Model: Finisher for the AD50		Date: 15-Sep-97	No: 1
Subject: New Product Information		Prepared by: S.Tomoe	
From: QAC 2nd Field Information Dept.			
Classification:	<input type="checkbox"/> Troubleshooting <input type="checkbox"/> Part information <input type="checkbox"/> Action required <input type="checkbox"/> Mechanical <input type="checkbox"/> Electrical <input checked="" type="checkbox"/> Service manual revision <input type="checkbox"/> Paper path <input type="checkbox"/> Transmit/receive <input type="checkbox"/> Retrofit information <input type="checkbox"/> Other ()

The new Finisher (SR710) is being developed as a peripheral for the AD50, which will be launched this November. This RTB clarifies the differences between the SR700 and the SR710.

Model: AD50		Date: 30-Sep-97	No: 2
Subject: Incorrect screw information		Prepared by: S.Tomoe	
From: QAC 2nd Field Information Dept.			
Classification:	<input type="checkbox"/> Troubleshooting	<input type="checkbox"/> Part information	<input type="checkbox"/> Action required
	<input type="checkbox"/> Mechanical	<input type="checkbox"/> Electrical	<input type="checkbox"/> Service manual revision
	<input type="checkbox"/> Paper path	<inp

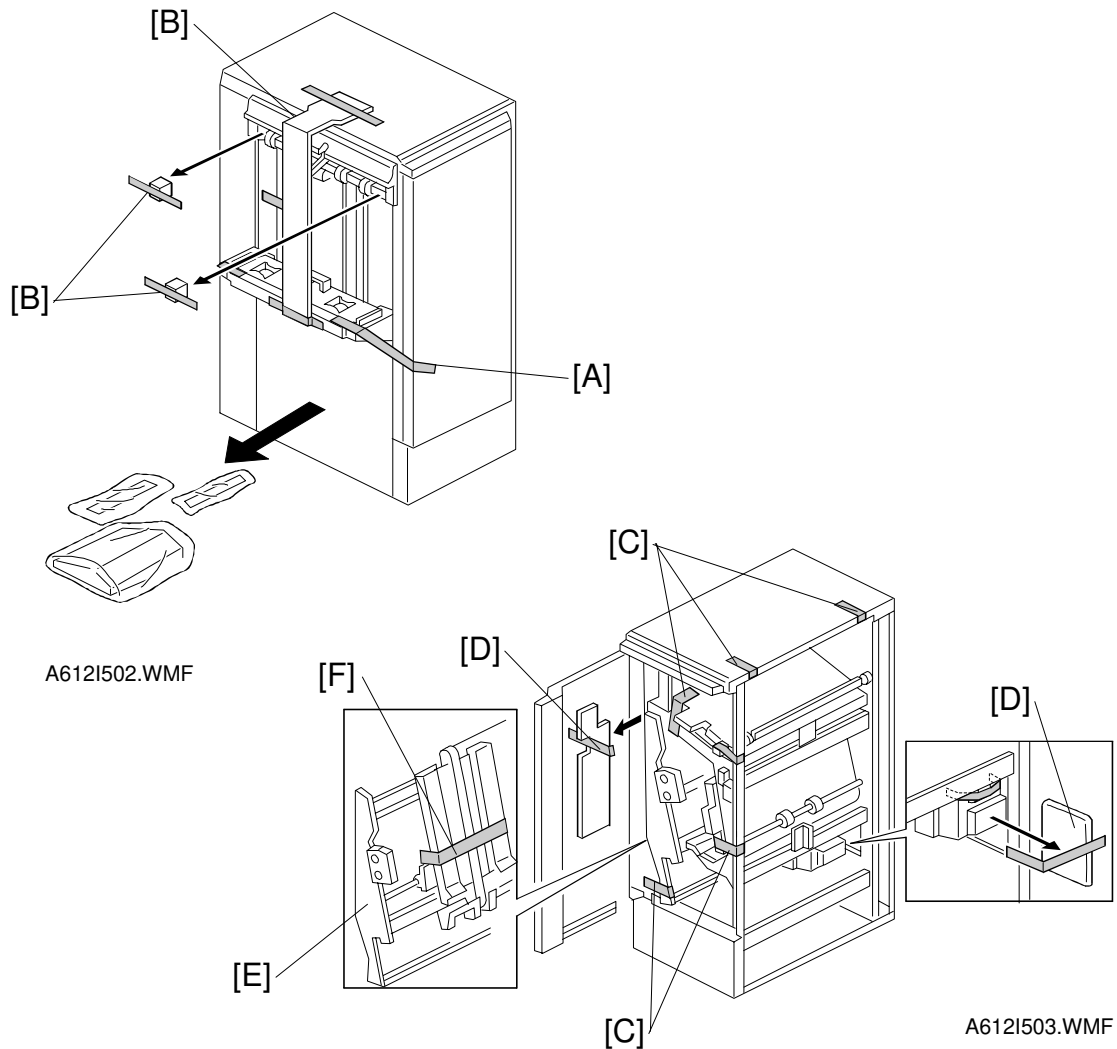
1) Increased paper speed at the entrance of the unit

The AD50 copy speed is 50 cpm. So, the paper speed at the entrance of the unit has been increased from the SR700 (200 mm/s → 250 mm/s). Therefore, the transport drive motor has been changed.

2) Two grounding plates have been removed

Due to a change in the European Radiation Standard Class (EN55022) of the AD50 from class B to class A, two grounding plates are no longer necessary to install the unit. Therefore, the installation procedure of the finisher has been changed (refer to the attached installation procedure).

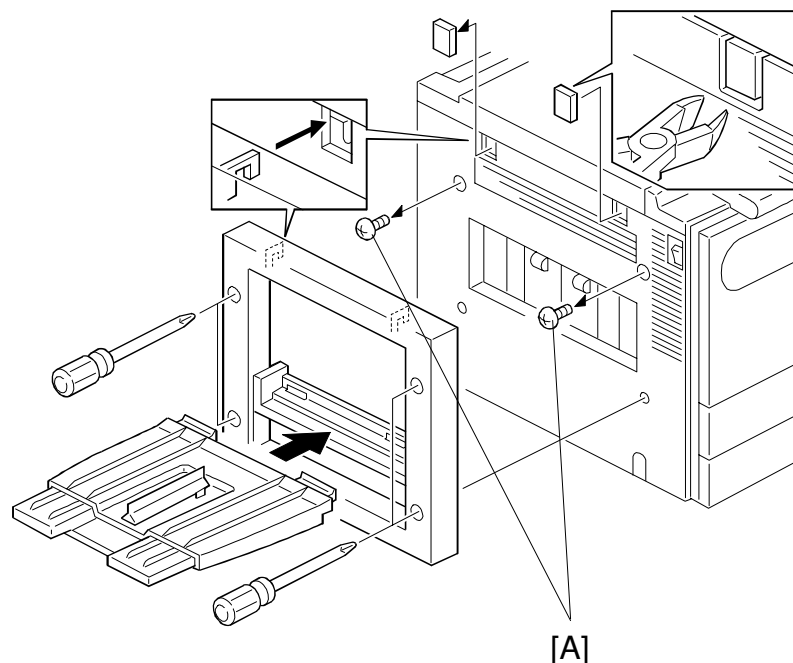
The screws [A] which are removed when the optional 500-sheet tray is installed, are truss screws. However, the September production run began incorporating knob screws. However, during the next production (around October) these screws will be reverted to truss screws.

Please note that It is not necessary for field technician to change these screws in the field.

Entrance Guide Installation Procedure

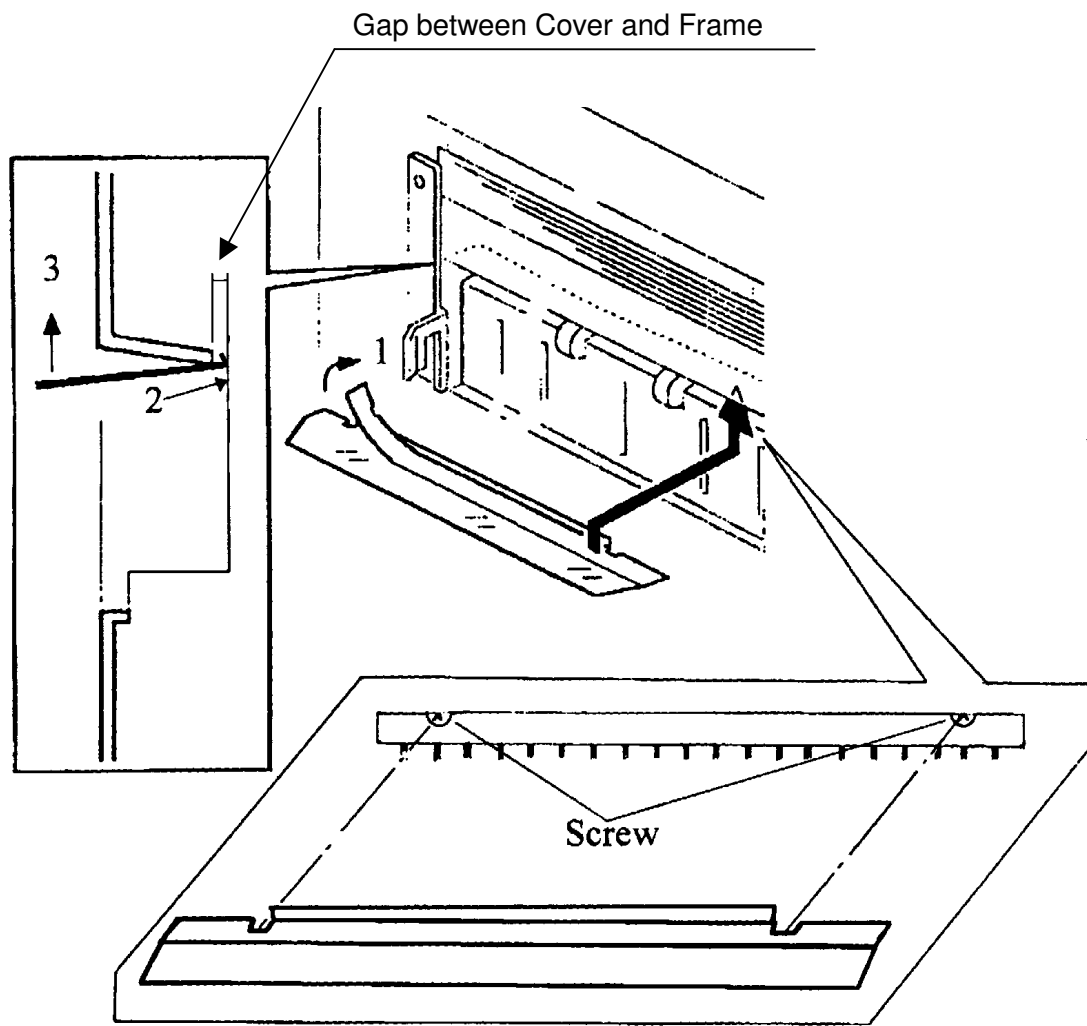
For machines on which the Finisher is installed, if a large amount of copies is made right after power-up, SC101 may occur. If the Entrance Guide is installed in the proper position, this problem may be prevented. Please refer to the attached page for the installation procedure.

If the Entrance Guide is not installed in the proper position, a gap may develop between the Cover and the Main Frame through which the heat and humidity generated by the paper may enter and lead to high temperature/high humidity around the lamp stabilizer. If a large amount of copies is made right after the machine is turned on, the Lamp Stabilizer will warm up very quickly and may lead to condensation. This may lead to a short circuit and cause SC101.

The edges of the Entrance Guide have been bent to strengthen this part and make it easier to install. Please refer to SR710 MB#2 for the details regarding this modification.

During the set-up of a Finisher manufactured after May 1997, please install the Entrance Guide in a manner that will prevent a gap from developing between the Cover and the Main Frame. Please refer to the attached page for this procedure.

In the event that an SC101 occurs on a Finisher manufactured before April 1997, please replace the Entrance Guide with part number A6122333.

1. Peel off the tape seal for the Entrance Guide.
2. Place the Entrance Guide on the Main Frame.
3. Attach the Entrance Guide to the Cover.

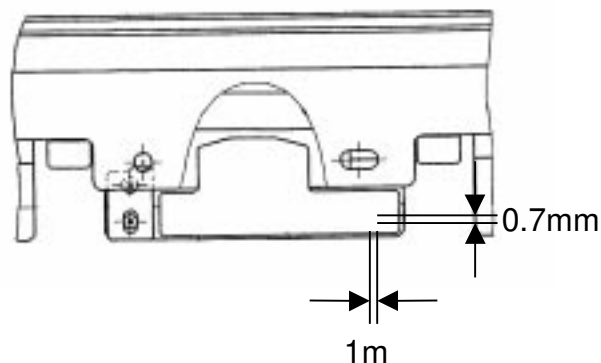
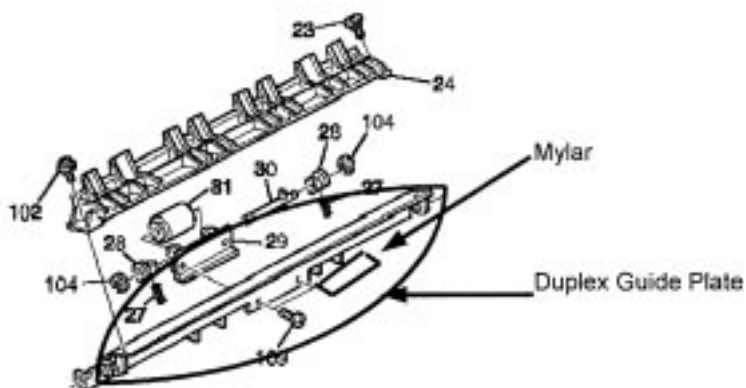
1. During paper feed from the duplex unit, the leading edge of the paper is bent or a no-feed jam occurs.
2. During stacking in the duplex unit, a stacking jam occurs.

1. Paper feed jam (leading edge bent or non-feed)
 - 1) Check to see if the duplex guide mylar is set properly. If it is bent or out of position, please replace ***the duplex guide mylar (A1344670)*** or the duplex guide plate ***(A1344662)***.

Method: Rotate the feed roller by hand. If it makes a clicking sound it is OK.

(If the mylar is bent or out of position, the leading edge of the copy may be bent or no-feed jams may occur.)

Reattaching the mylar (as shown below) is a temporary countermeasure. As a permanent countermeasure, the duplex guide plate should be replaced.

Spring clutch as viewed from the rear of the unit

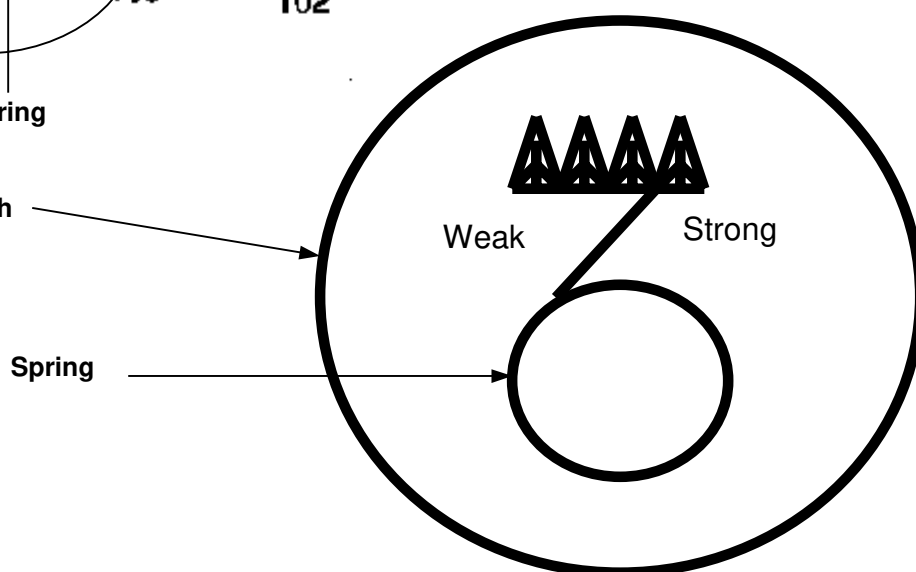
- 2) If 1) does not solve the problem, change the position of the spring in the spring clutch to increase the pressure on the bottom plate, or replace the spring clutch.
 - By adjusting the spring setting, the pressure on the bottom plate in the duplex unit increases. The stronger the setting, the more effective it is.
(If the pressure on the bottom plate is insufficient, no-feed paper jams may occur.)

There are 3 settings for the spring. The one on the right is the strongest.

- 3) If 2) does not solve the problem, change the spring clutch (P/N AB040015) to a modified one (P/N AB040017). (Refer to an MB for the details of the modification.)

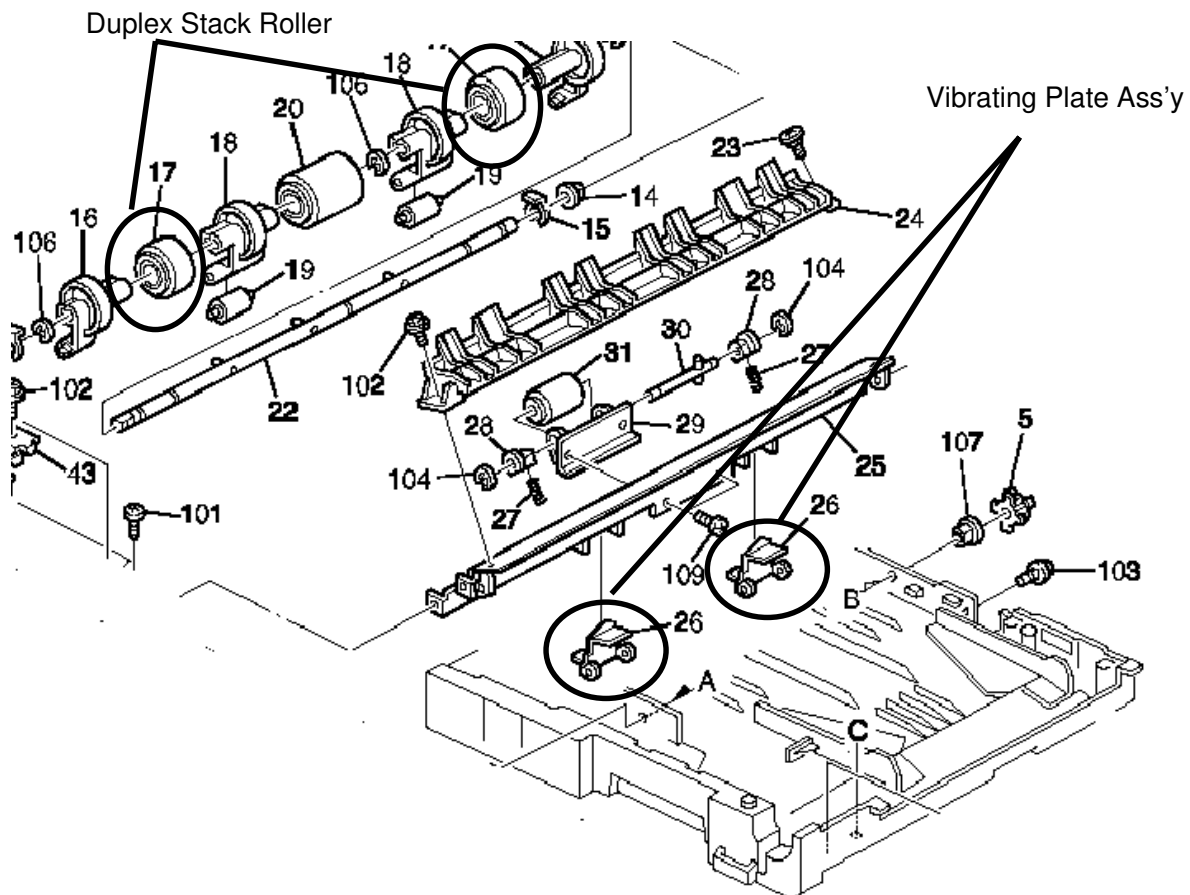
- 1) Check the condition of the mylar on the vibrating plate ass'y. If it is bent or damaged, replace the vibrating plate ass'y (A1544626)
 Rotate the duplex stack roller. If it makes a clicking sound, it is OK.
 (If the mylar is bent or damaged, stack jams may occur.)

- Duplex Jam indicated = OK -

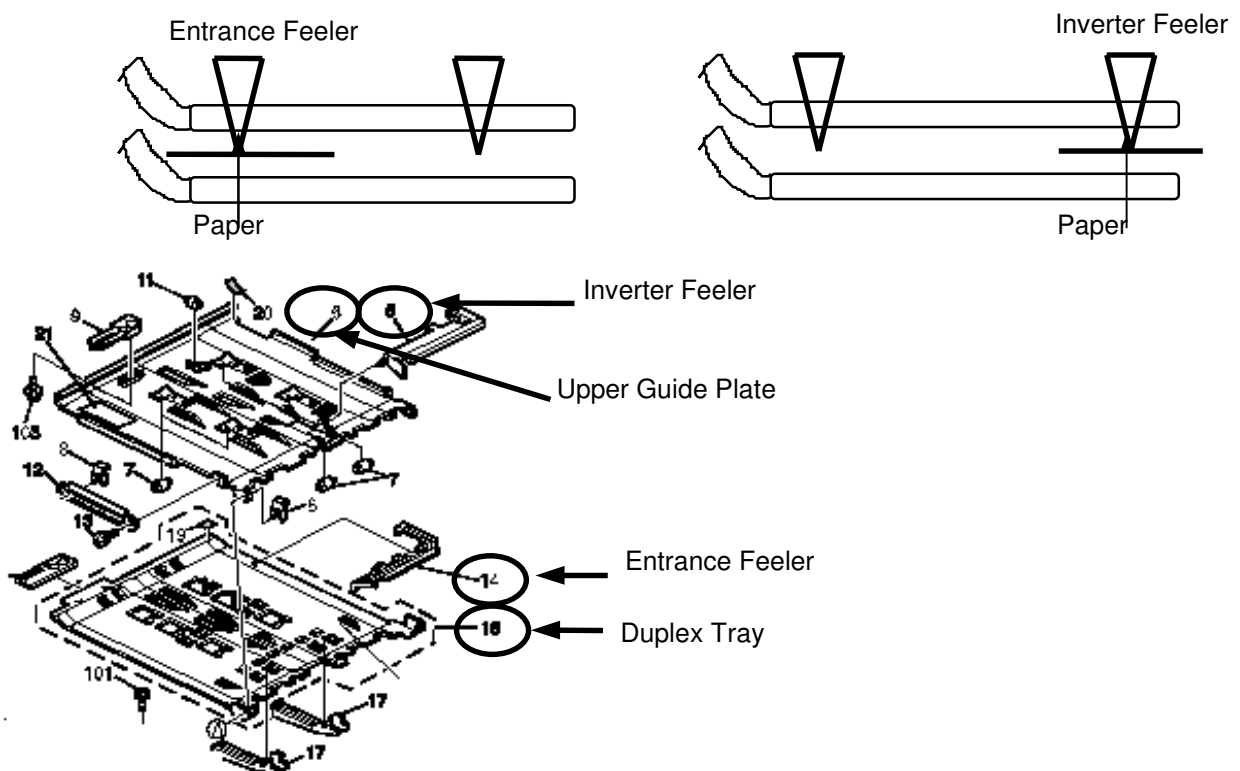
- 2) Check to see if the upper guide plate (A13444732) or the duplex tray are deformed. If so, replace the parts.

Check procedures: Pull out the duplex unit and put paper in between the upper guide plate and the duplex tray as shown below. Next, insert the tray and note whether or not duplex jam is indicated. If it is, then it's OK. (This checks the inverter feeler detector and the entrance feeler detector.)

- Please inform the users that they should pull out the duplex unit all the way when removing paper when a jam occurs. If the duplex unit is only pulled out part way, this may lead to deformation of the upper guide plate and the duplex tray.
